Subject: MHI's Responses to US-APWR DCD RAI No. 756-5753 Revision 3 (SRP 09.01.03)

US-APWR Design Certification

RAI NO.: NO. SPBA 756-5753 REVISION 3
SRP SECTION: 09.01.03 – Spent Fuel Pool Cooling and Cleanup System
APPLICATION SECTION: 8.3.1 AND 9.1.3
DATE OF RAI ISSUE: 5/11/2011

QUESTION NO.: 09.01.03-8

Figure 9.1.3-1 Schematic of Spent Fuel Pit Purification and Cooling System (Cooling Portion)

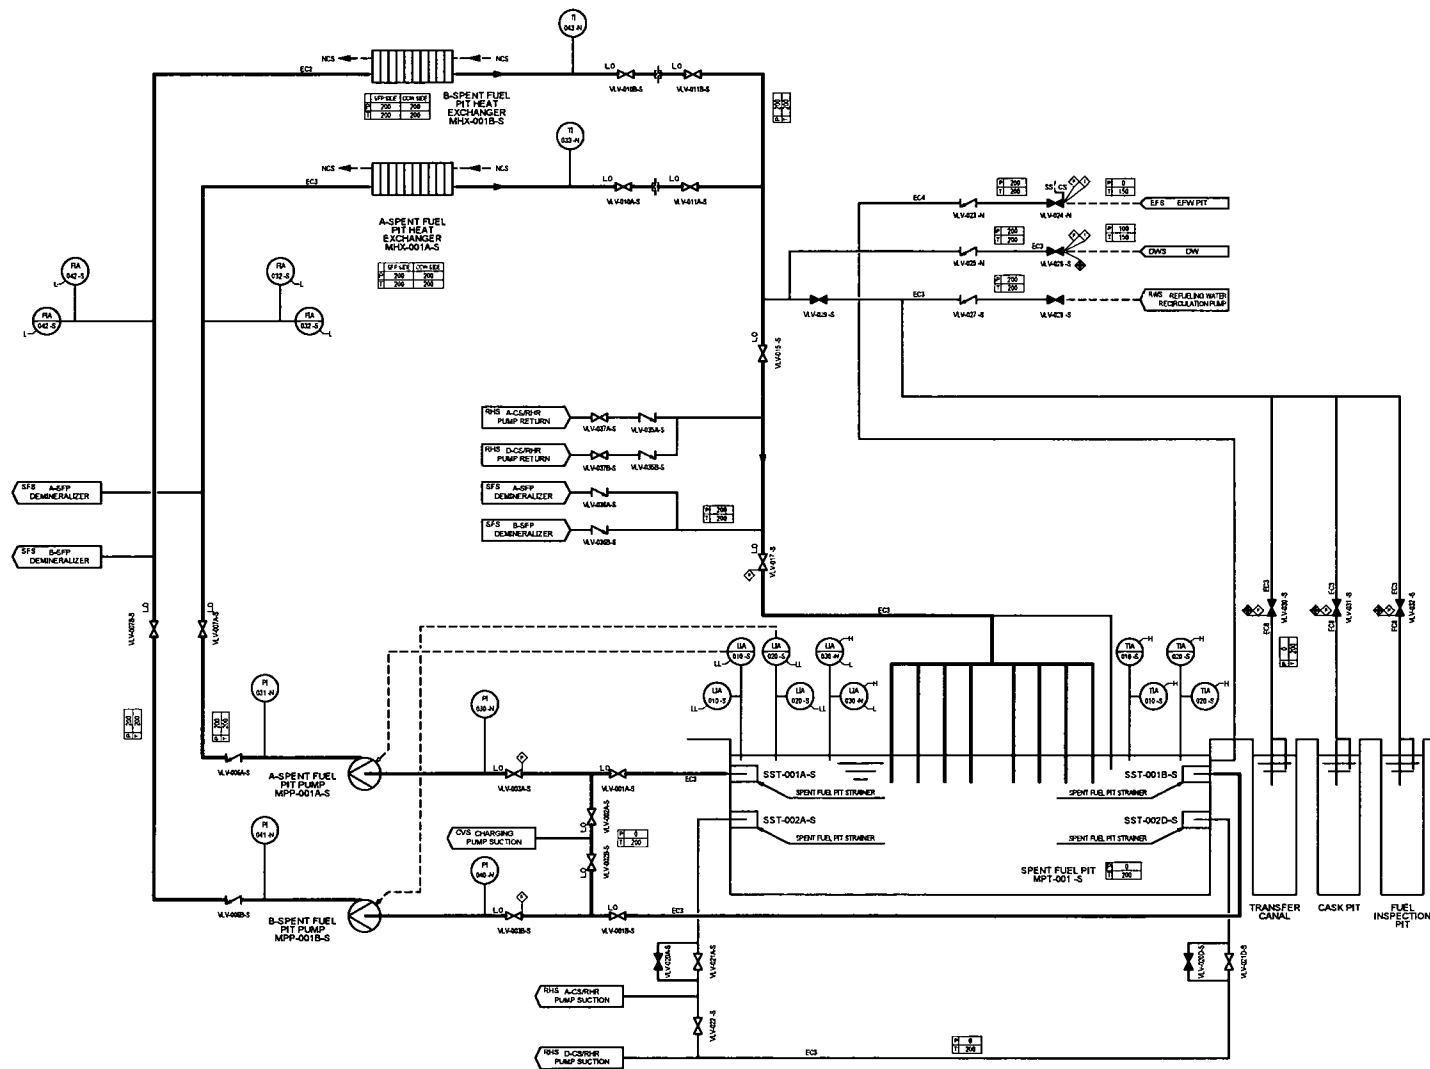
The staff requests that the applicant clarify this apparent discrepancy. If the description in DCD Tier 2 Section 9.1.3 is not correct and the SFP cooling is stopped by the ECCS actuation signal, the applicant needs to modify DCD Tier 2 Section 9.1.3 to address this scenario and the following:

- a) The applicant should describe the safety related instruments credited to monitor the SFP conditions (e.g., temperature and water level) while the SFP cooling system is shutdown;
- b) The applicant should describe the minimum time available to re-establish SFP

- c) The applicant should describe the operator actions required to re-establish SFP cooling in a timely manner.

- Revise the figure 9.1.3.1 to reflect the changes regarding instrumentation appropriately.
